CITY OF ALBUQUERQUE

Re: Santa Barbara Multigenerational Center
1825 Edith Blvd. NE
90-Day Temporary Certificate of Occupancy
Transportation Development Final Inspection
Engineer's Stamp dated 05-26-23 (H15-D070)
Certification dated 06-06-24

RE: SBMT Multigenerational Center, 1825 Edith Blvd NE
Traffic Circulation Layout Certification (H15/D070)

SANTA BARBARA / MARTINEZTOWN
MULTIGENERATIONAL CENTER

C-100

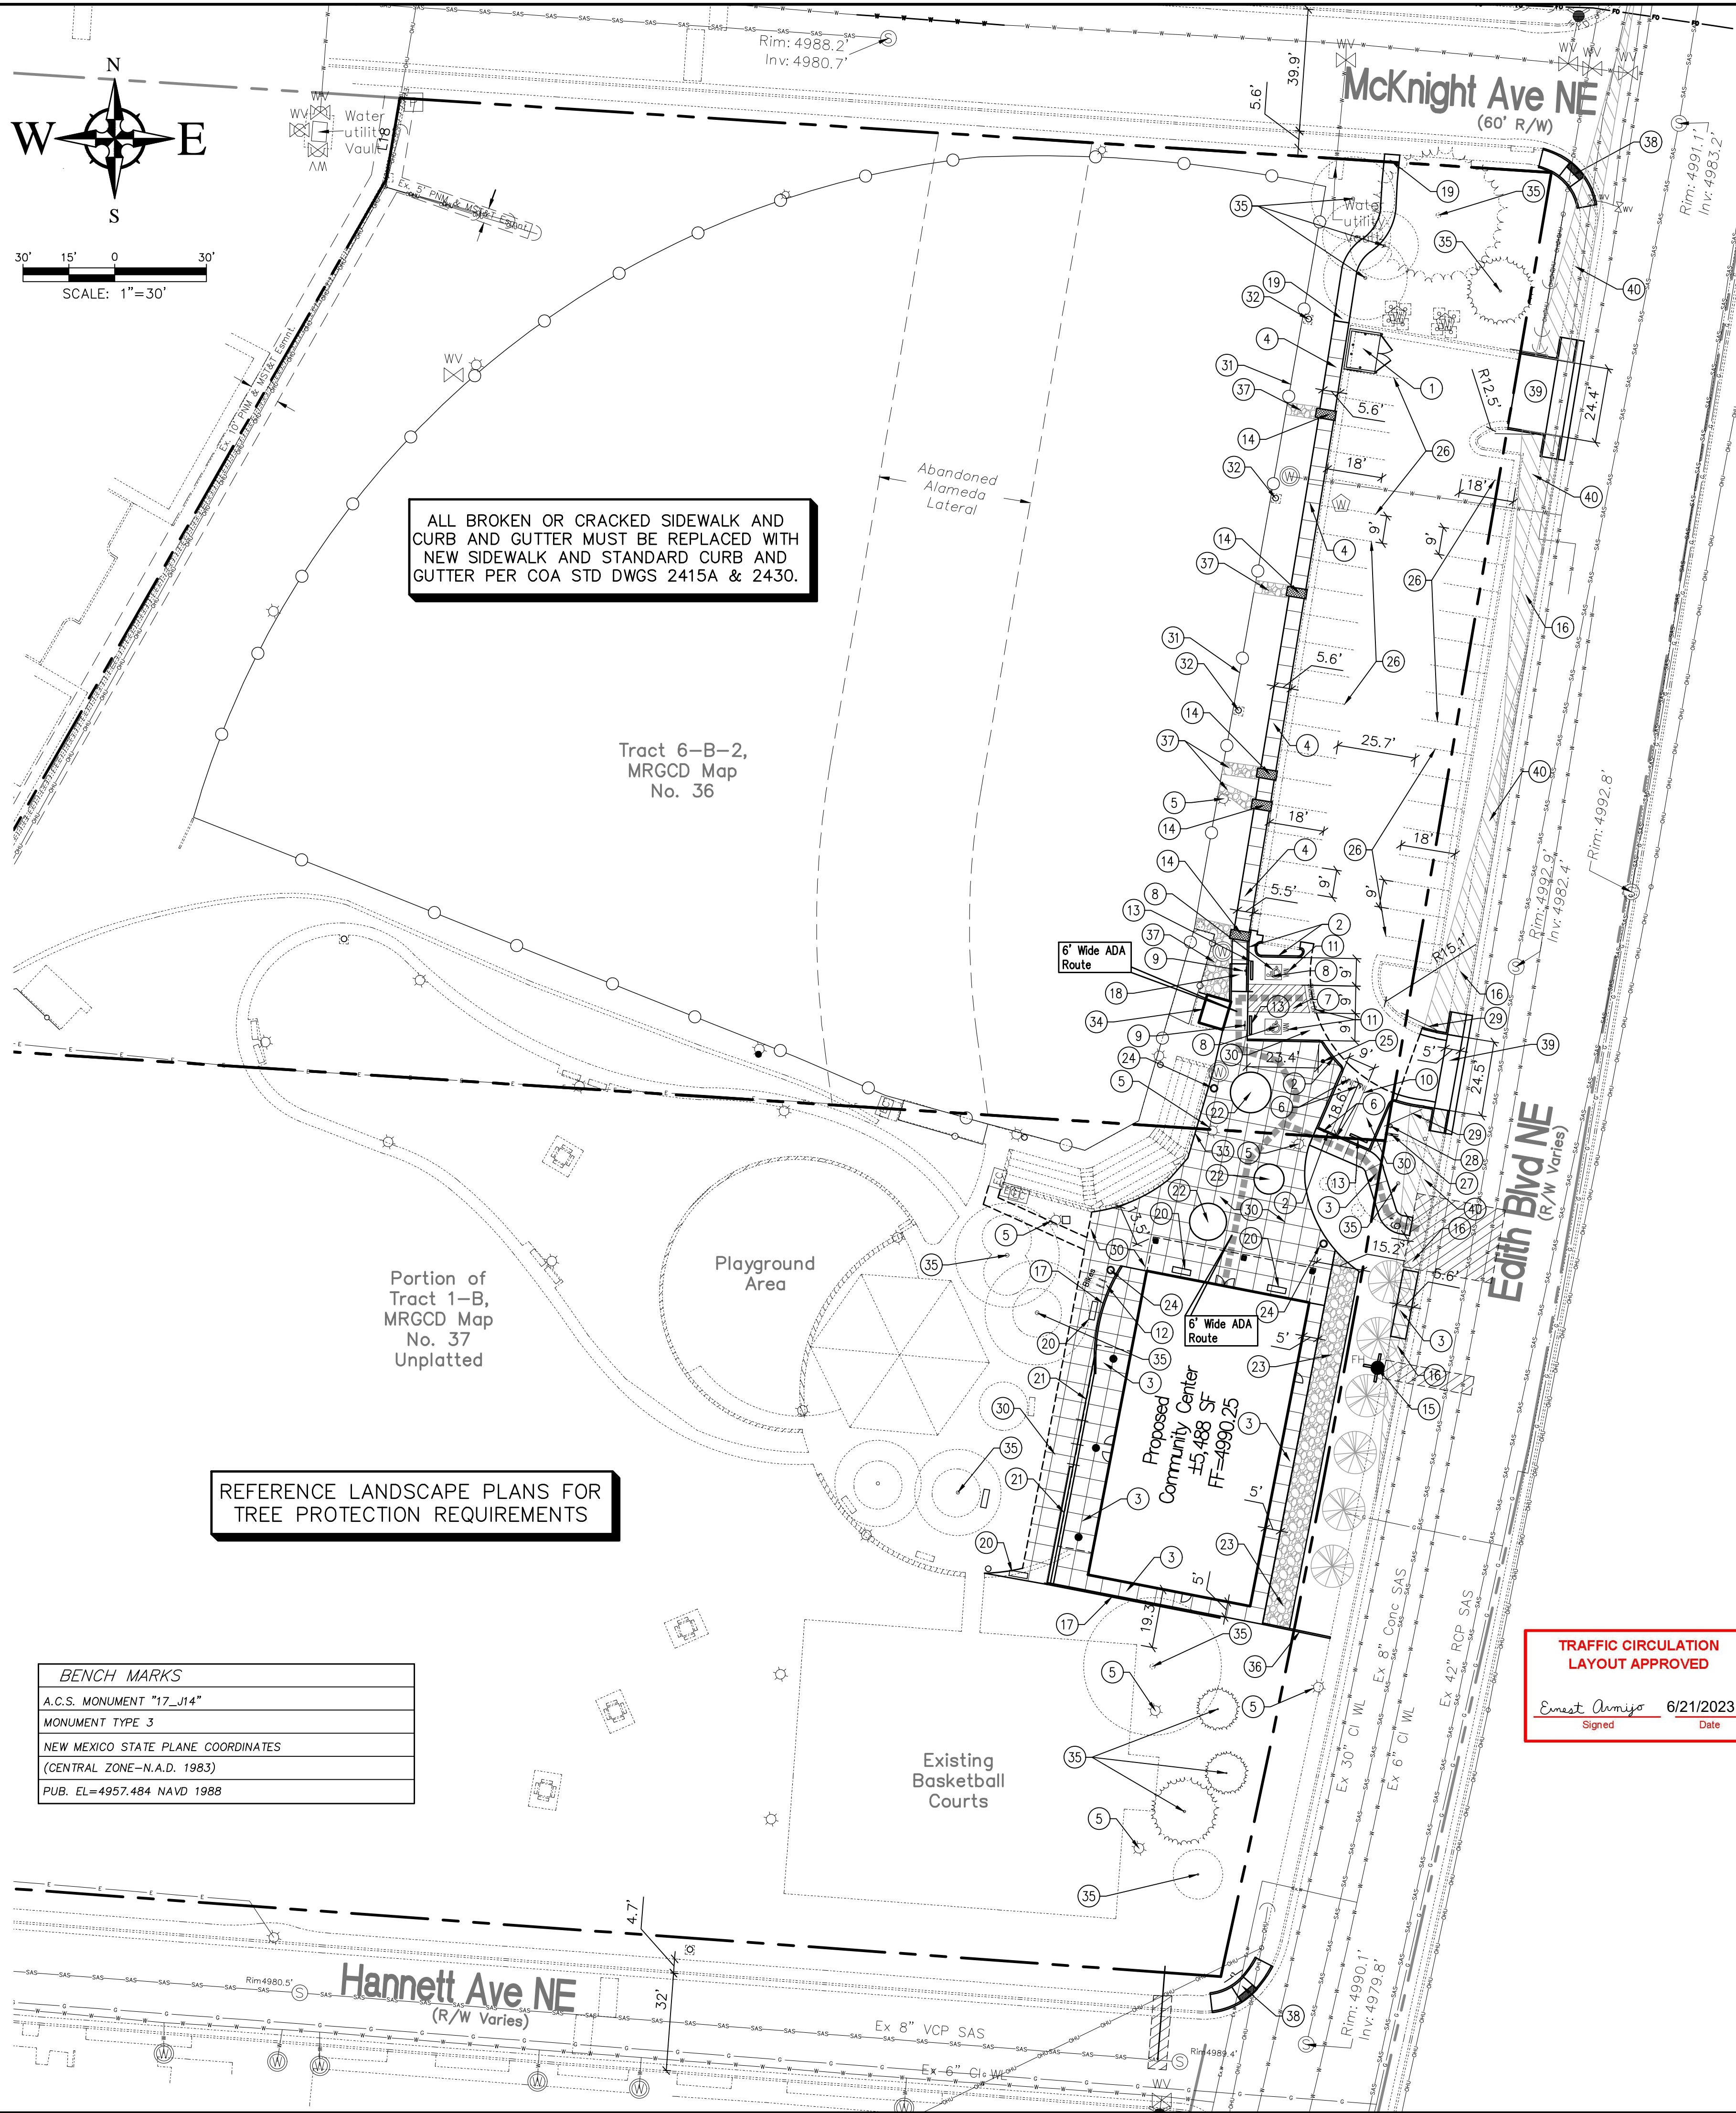
1. Site accesses, parking lot, and the City ROW corner ramps, must be built per city standard as mentioned in the approved site plan.

- The curbs that stick up above grade could be a tripping hazard and need to be painted traffic yellow.
- The ADA route sidewalk slightly exceeds a 5% (1:20) slope and needs to be rebuilt with a 5% maximum slope to keep from needing handrails.
- The parking lot needs to be striped and signage needs to be installed.
- The curb cuts onto Edith Blvd still need to be reconstructed. These curb cuts will need to be built one at a time so that there is continuous access to the parking facilities. Some parking spaces will need to be temporarily blocked off during construction in order to allow for vehicles an area to turn around.
